SERVICE BULLETIN

SERVICE BULLETIN		No.: MSB-97E26-001 REV	
		Date: 1997-12-05	<Model> <M/Y>
Subject:	CHANGE OF FRONT ROTOR FOR ABS EQUIPPED VEHICLES (REVICED)	(EC,EXP) L400 (PA0V)	97-10 97-10
Group:	FRONT AXLE	Draftno: 96-SY-18	(EC,EXP) PAJERO (V10,V20,V30,V40)
INFORMATION	OVERSEAS SERVICE DEPT	 R. USAMI - MANAGER QUALITY INFORMATION ANALYSIS

DISASSEMBLY AND REASSEMBLY (Front Axle Hub)

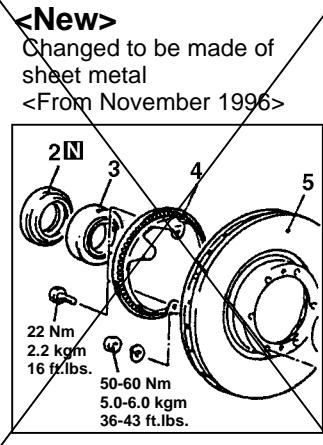
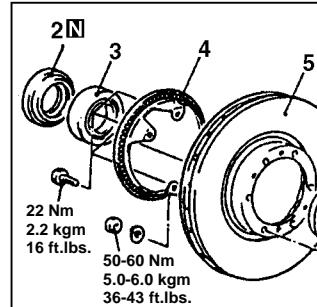
Changed to be made of sheet metal
<From November 1996>

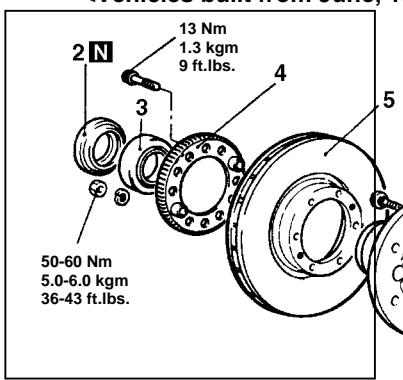
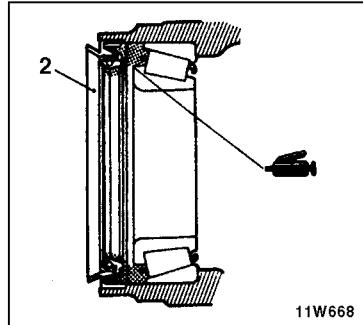
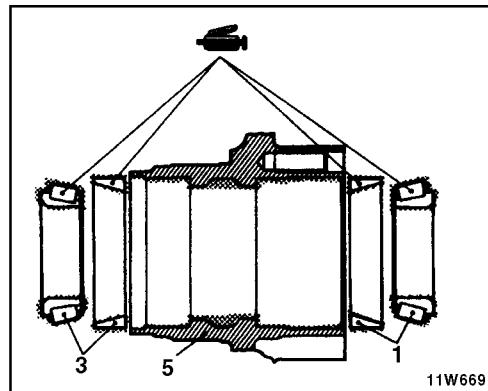
Two bolts changed to four bolts
<From November 1996>
